RE: Revised Draft §401 Water Quality Certification for the Draft NPDES Permit No. ID-0020842 for the City of Sandpoint Wastewater Treatment Plant

Idaho Department of Environmental Quality Draft §401 Water Quality Certification

NPDES Permit Number(s): ID002842 City of Sandpoint Wastewater Treatment Plant

Image 3 Revised CORMIX Modeling Scenario Phosphorus Concentrations of $1463\mu\text{g/L}$ and $1899\mu\text{g/L}$; Facility Design Flow of 5mgd; River Flow of 6,640cfs

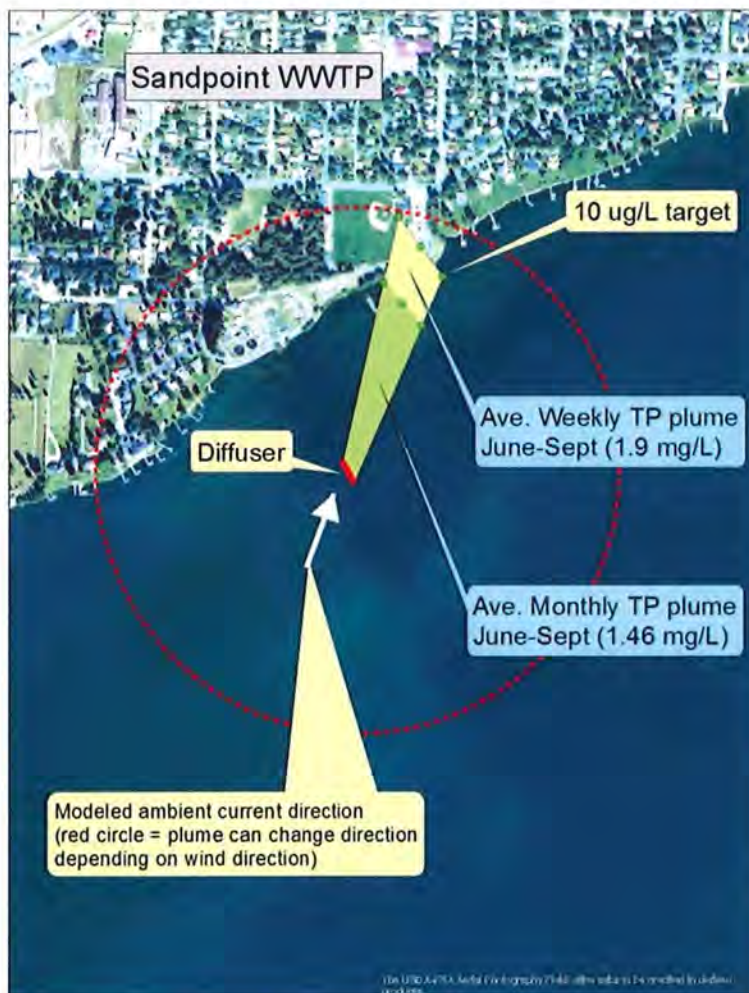
Image 3 illustrates the results of the CORMIX modeling effort that used the additional 2015 river data and a lower summertime phosphorus concentration of $1463\mu\text{g/L}$ (which is equivalent to the proposed permit limit of 61lbs/day from June-September). It also examined the average weekly permit limit of 79 lbs/day (June-September) which is equivalent to a concentration of $1899\mu\text{g/L}$. The green shaded area represents the average monthly limit mixing zone and the yellow shaded area represents an additional area of mixing allowed by the average weekly limit. The red dotted line indicates that the mixing zone can pivot in any direction due to slack water at the diffuser location. The shape of the mixing zone is also variable depending on wind direction and speed, boat traffic and localized currents. The model also reflects a lower critical flow than shown in Image 2 based on comments from the Kalispel Tribe.

After reducing phosphorus concentrations during the critical low flow time period from the first draft permit, modeling results as illustrated in Image 3 reduced shore hugging plumes and shows a more localized mixing zone. These conditions better align with the mixing zone policy. Appendix D of this certification further investigates the effects of the proposed phosphorus limits on the river.
